CITY OF ALBUQUERQUE

Re: Manual Shops
7212 Manual Blvd 87110
60-Day Temporary Certificate of Occupancy
Transportation Development Final Inspection
Engineer's/Architect's Stamp dated 6-3-19 (H19D040)
Certification dated 6-10-20

TRAFFIC CERTIFICATION

PROJECT #1822
MENAU SHOPS
SITE PLAN
7212 MENAU BLVD NE 87110
ALBUQUERQUE, NM

REVISION DATE
DATE: 05-30-2019
SHEET NUMBER: AS-1.0

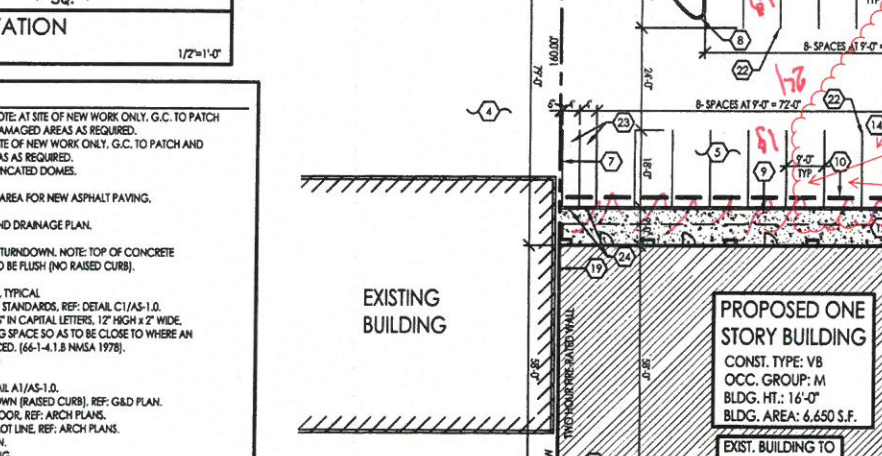
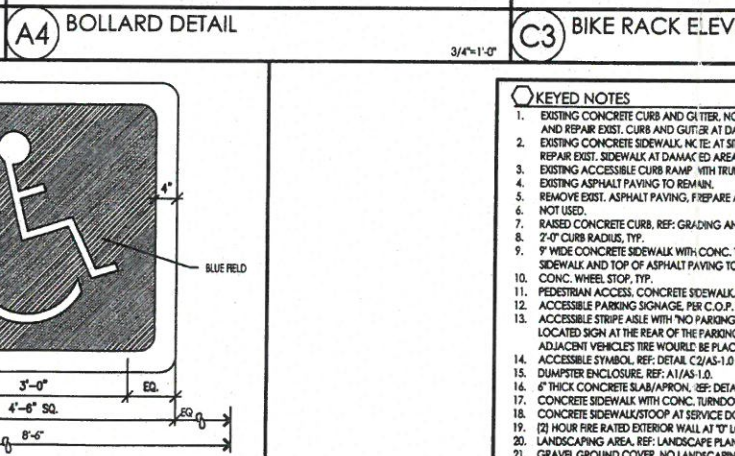
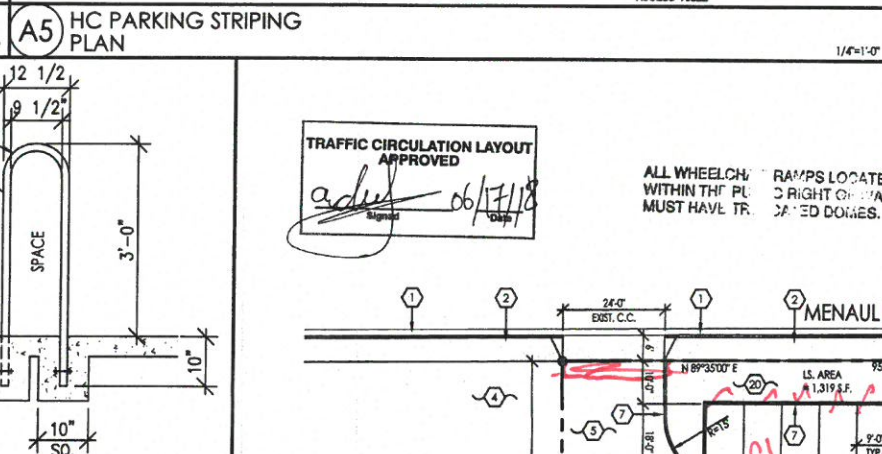
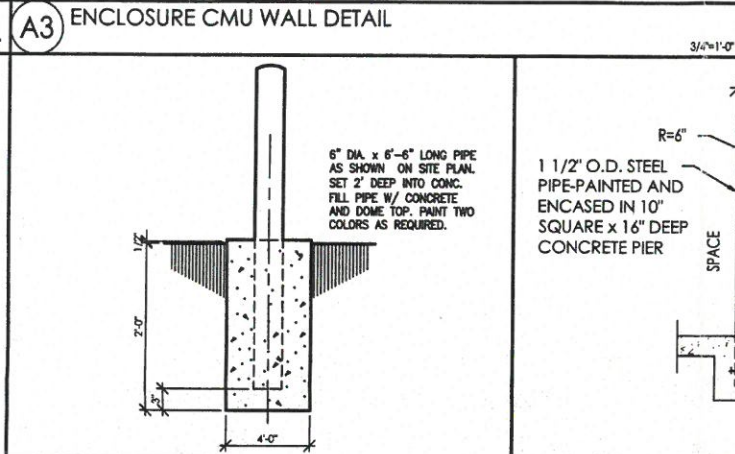
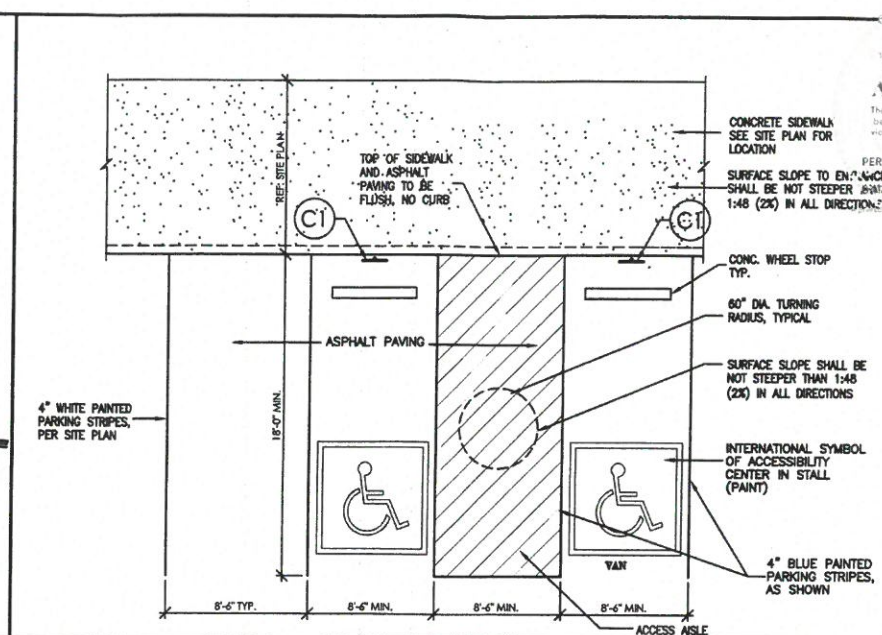
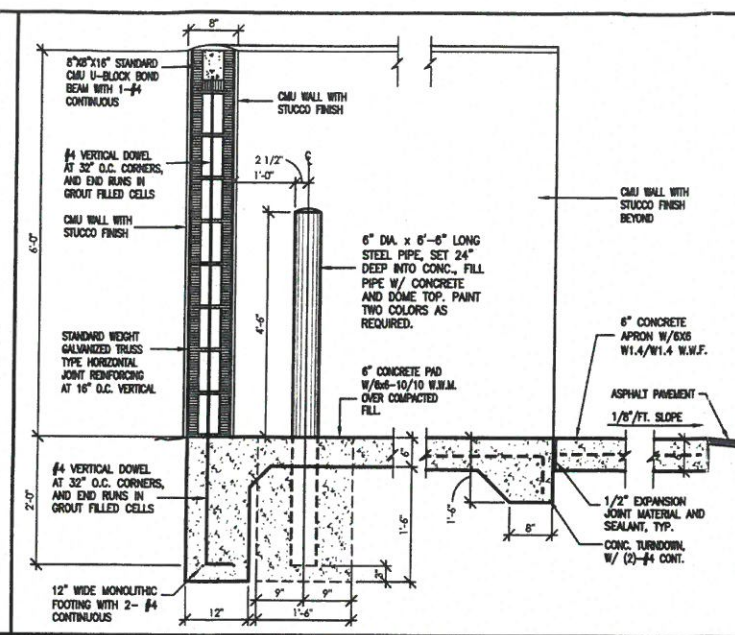
- Alley wall (Resolution Pending)...

(2) ACCESSIBLE PARKING SPACES MOVED (3) PARKING SPACES TO THE WEST

CMU RETAINING WALL FROM BUILDING WALL TO SOUTH PROPERTY LINE
